COMMITTEE OF THE WHOLE APRIL 7, 2003

**BLOCK 18 BLOCK PLAN
FILE BL.18.98
CARRVILLE - URBAN VILLAGE 2**

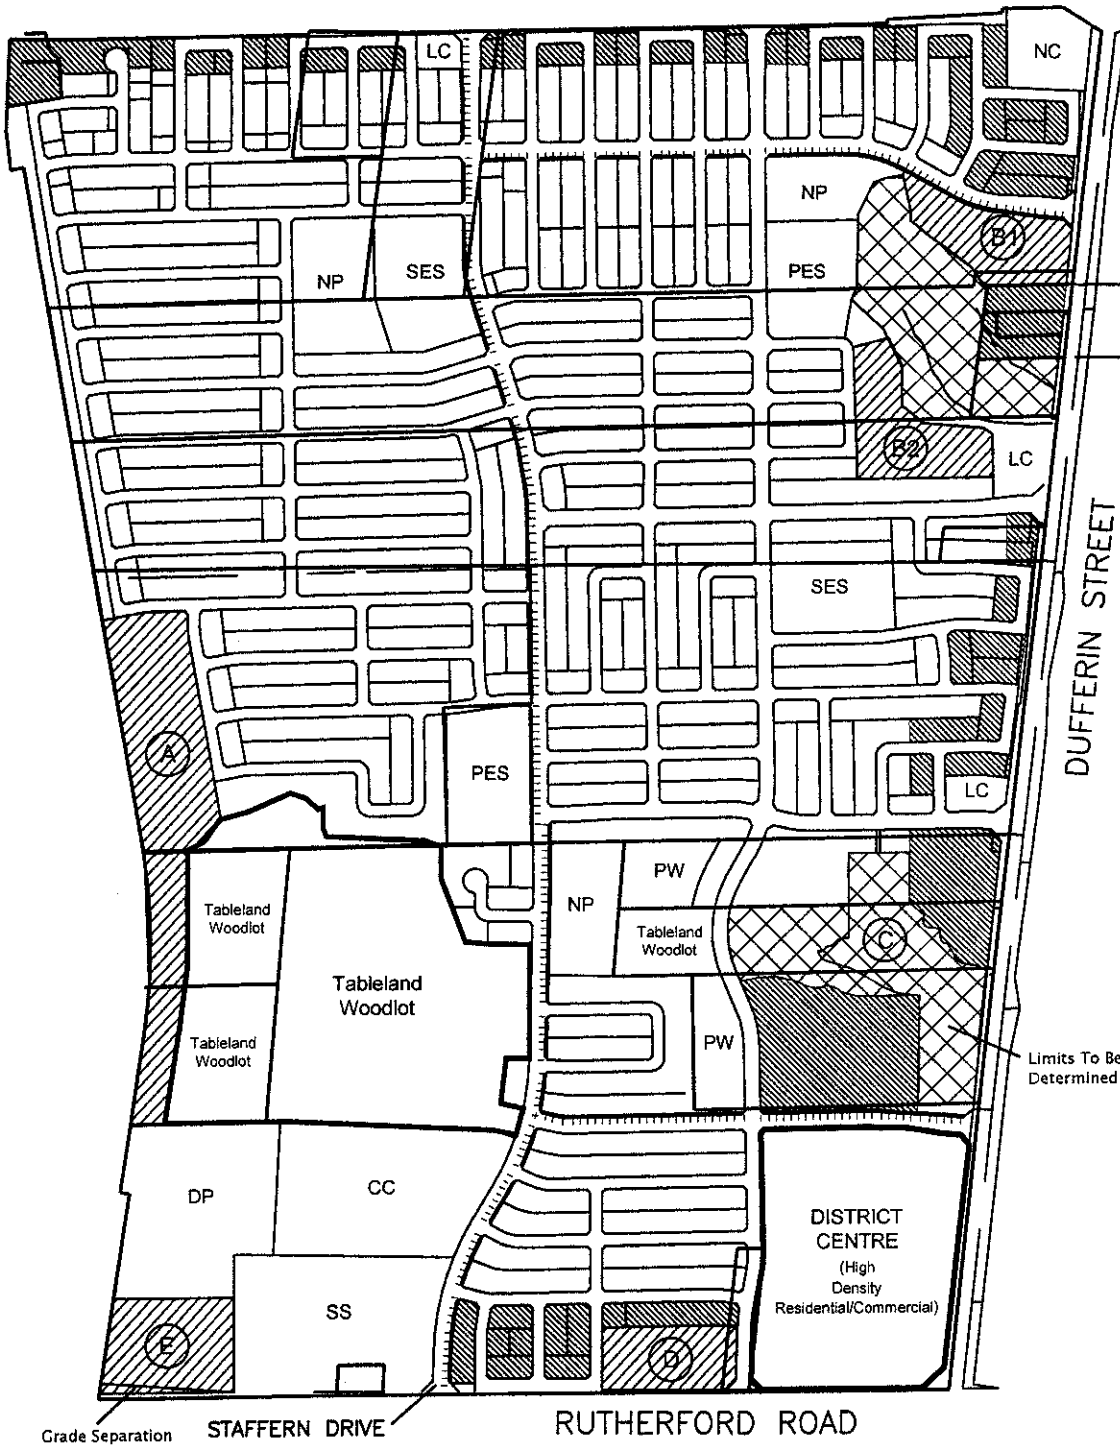
- 1) That the Block 18 Plan, dated March, 2003, as red-line revised, BE APPROVED subject to the following conditions:
 - a) That the Block 18 Plan be revised to address the following matters:

- to add road links to improve internal connectivity;
 - to address lotting at primary/arterial intersections to minimize driveways adjacent to the medians;

- to widen the primary roads, particularly in front of the elementary school sites, to accommodate traffic management measures;
 - the block along the southerly part of the woodlot fronting onto Staffern Drive be developed comprehensively with a single access point opposite to an intersection;

- to provide a mid-block pedestrian crossing over the CN railway to the residential neighbourhood to the west, and a pedestrian bridge over Major Mackenzie Drive to the Maple GO Train Station, where feasible;

- to ensure that the property at the northwest corner of the block can be integrated into the final lotting and road configuration;
 - to adjust the lots/blocks adjacent to the valley and stream corridor, stormwater management pond facilities and woodlots once preliminary grading plans are submitted and the limits and buffers of open space features are determined;

- to finalize the size and configuration for all Storm Water Management Ponds;
 - to provide for 4m planted medians at the primary road entrances from the arterial roads;

- to indicate the Oak Ridges Moraine boundary;
 - to delete reference to "Study Area for SWM Ponds" and "Plantation Woodlot";
 - to defer land use approval for lands where Planning Act applications are submitted after November 16, 2001 until it is demonstrated that the proposed land uses conform to the Oak Ridges Moraine Conservation Plan;

- to defer development of the lands within the Pond "C" drainage area pending resolution of stormwater and related issues.
 - b) That the Block 18 Transportation Analysis update be revised to include a Sensitivity Analysis, which addresses traffic volume and management along the westerly north-south primary road (Staffern Drive), and traffic calming and internal traffic controls, for approval by the Vaughan Engineering Department.
